**EMERGENCY DROUGHT APPLICATION: GROUNDWATER REVIEW**

TO: Water Rights Section Date: 4/22/2021  
 FROM: Groundwater Section: Michael Thoma  
 Reviewer's Name  
 SUBJECT: Application G- 19099  Re-review; date of original review: ###/###/####

Applicant’s Name: Drost Land Co. County: Klamath

**Hydrographs for Area Wells**

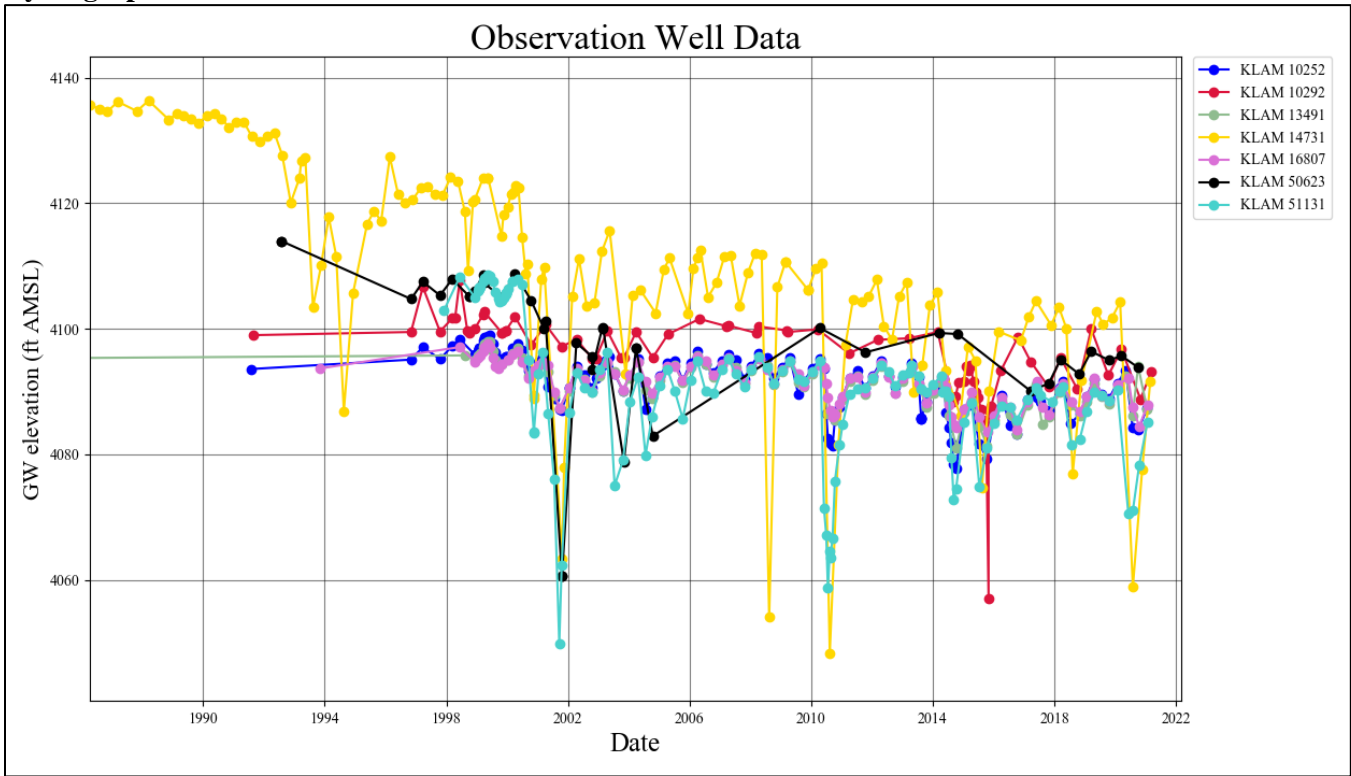
Seasonal groundwater level fluctuations in response to pumping in this area are generally on the order of 10-20 feet and most wells on groundwater rights are deep enough to accommodate this seasonal interference. However, long-term groundwater level declines have been documented throughout the area and are punctuated by drought-related groundwater pumping. Pumping related to 2021 emergency drought use by this, and other wells, is expected to exacerbate these declines, which has the potential to impact shallow wells.

Groundwater levels have declined noticeably across almost the entire Lost River Subbasin within the past 20 years and over 20 feet in some areas implying that the groundwater resource is over-appropriated as defined in OAR 690-400-0010. Increased use by drought-permit wells and supplemental groundwater rights are anticipated to continue these declines.

**Application Review Map**

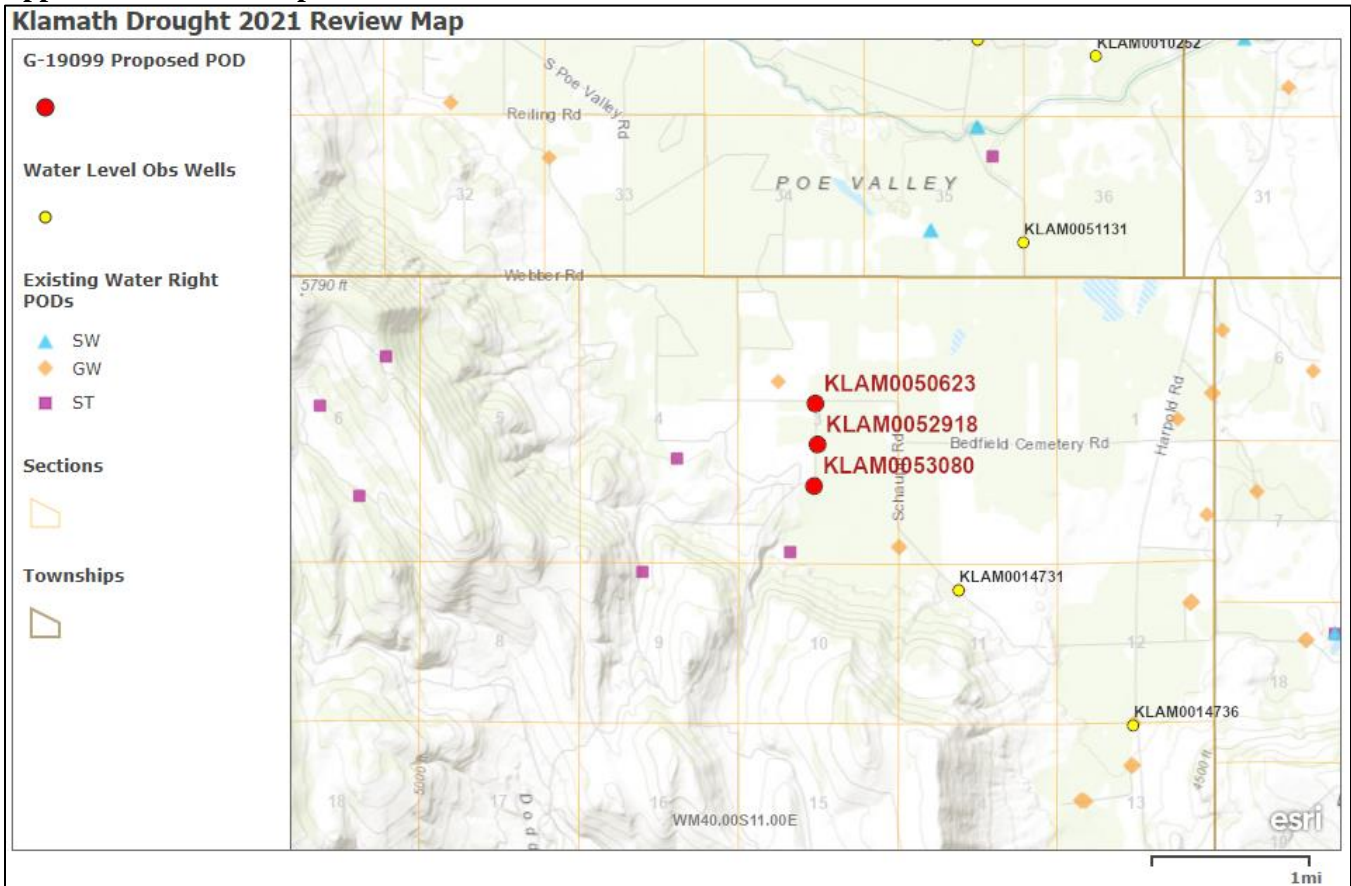
A1. Applicant(s) seek(s) 13.0 cfs from 3 well(s) in the Klamath Basin  
Lost River – Poe Valley Subbasin
